TECHNICAL MEMORANDUM

Revised Stormwater Infrastructure for Stage 2-5 Flagstone

Meinhardt Urban have been appointed by Peet Flagstone City Pty Ltd to prepare a review of the Stormwater Management Report – Stage 2-5 prepared by Cardno on 14 August 2012. The purpose of the review is to document key changes to the Stormwater Management Report (SMP) to support the Stage 2-5 RFI submission (June 2018).

Figure 1 – Revised Catchment and Basin Locations

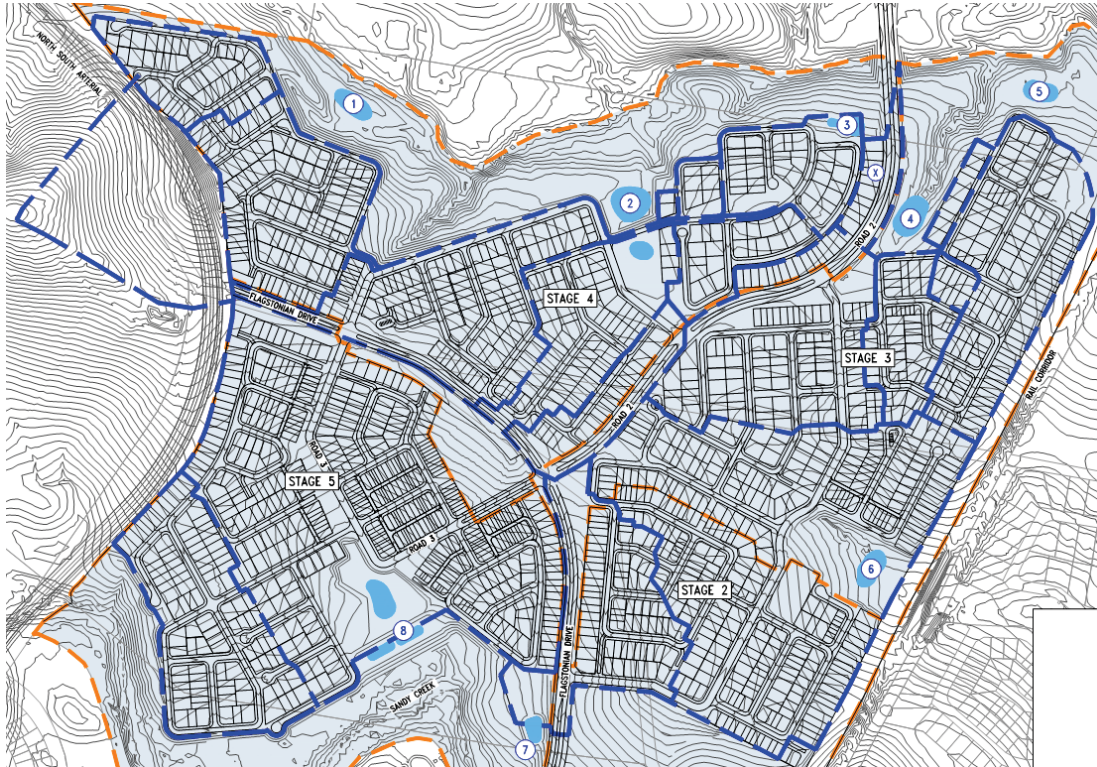
- Whilst all basins have been sized to meet AEP 63% detention requirements, the Stage 2 basin (Basin No. 6) has been sized to detain both 63% AEP and 1% AEP to predeveloped peak flows. This is to ensure that the downstream cross drainage culvert in Silverwood Drive meets major storm transverse flow limits as recommended in QUDM.

- The introduction of a Constructed Lake in Stage 5 (Basin No. 8). Whilst this lake will achieve a range of landscape and aesthetic objectives, the operations of the lake will be supported by treatment devices such as a sediments basin and bio-retention basin.

Apart from the above, the key changes to the Stage 2-5 SMP are restricted to changes in catchment boundaries and basin locations.

The key basin locations are located in Figure 1 below:
